Amendments to the Drawings:

REMARKS/ARGUMENTS

Fig. 1

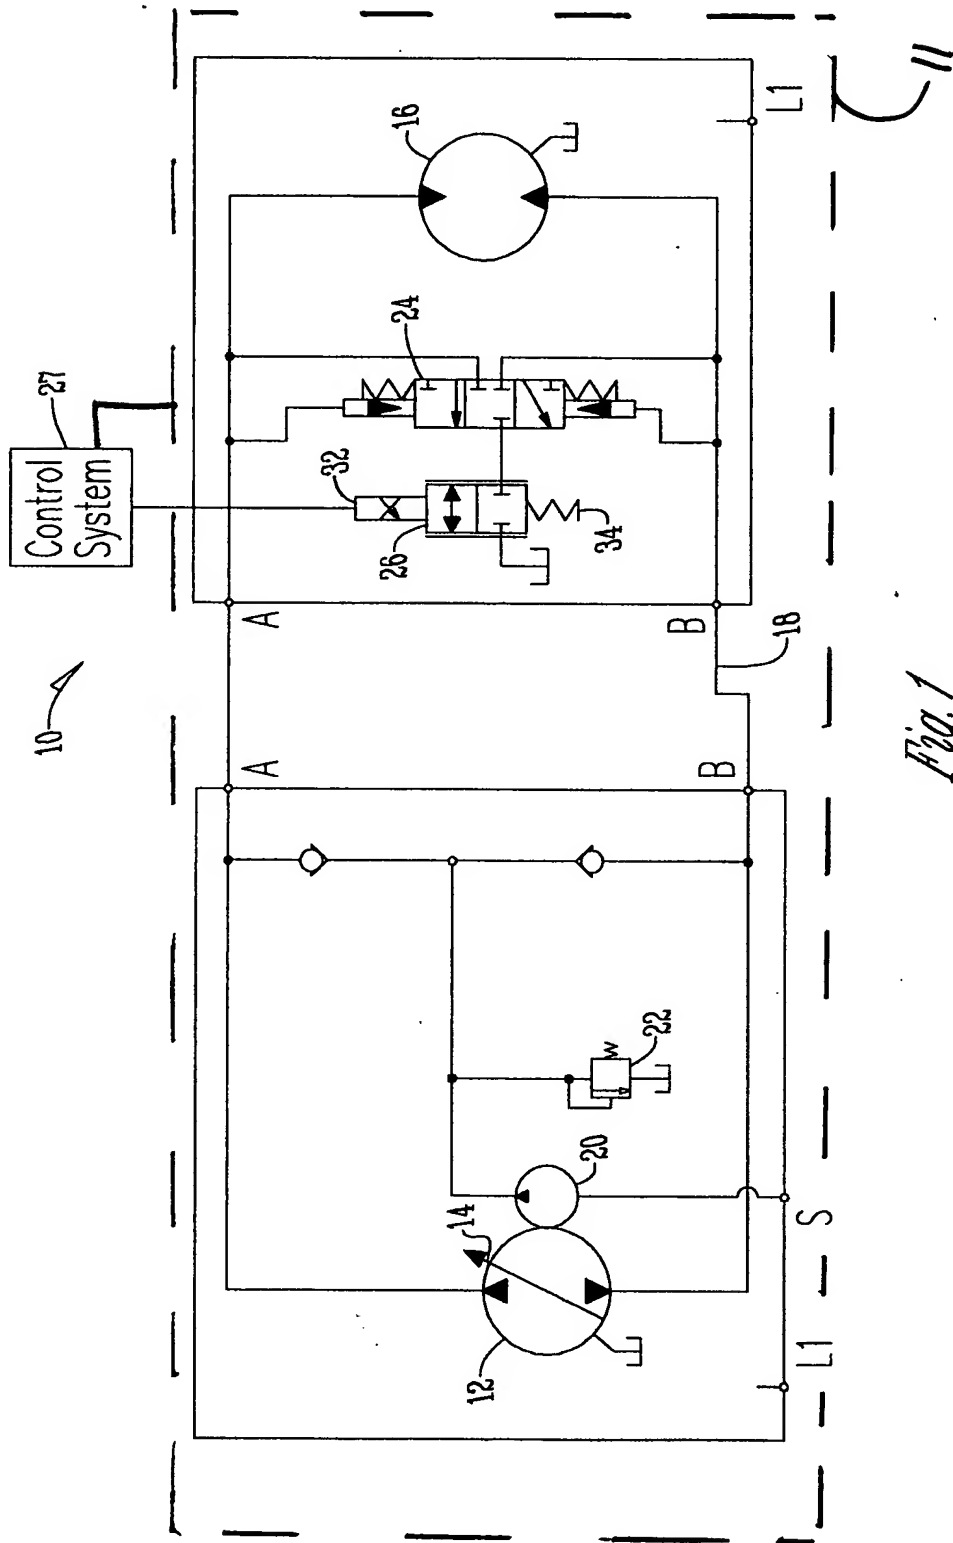
The attached sheets of drawings include changes to Fig. 1 and Fig. 2. These sheets replace the original page 1 and page 2 sheets of Fig. 1 and Fig. 2. In Fig. 1 and Fig. 2, a dashed line indicating hydraulic system 11 has been added along with a lead line connecting control system 27 to the hydraulic system 11.

The Examiner has objected to the drawings under 37 C.F.R. § 1.83(a) for not showing every feature of the invention specified in the claims. Specifically, the Examiner objects to the Figures not showing "the control system controlling the proportional valve based on pressure in the system lines (e.g. claim 1, lines 11-14) must be shown or the feature(s) canceled from the claim(s)."

Additionally, Figs. 1 and 2 have been amended to define which portion of the system 10 constitutes the hydraulic system 11. Further, as the specification (at page 8, lines 8-21) describes the control system as detecting the operational parameters of the hydraulic system, a lead line has been drawn from control system 27 to the hydraulic system 11 in both Figs. 1 and 2.
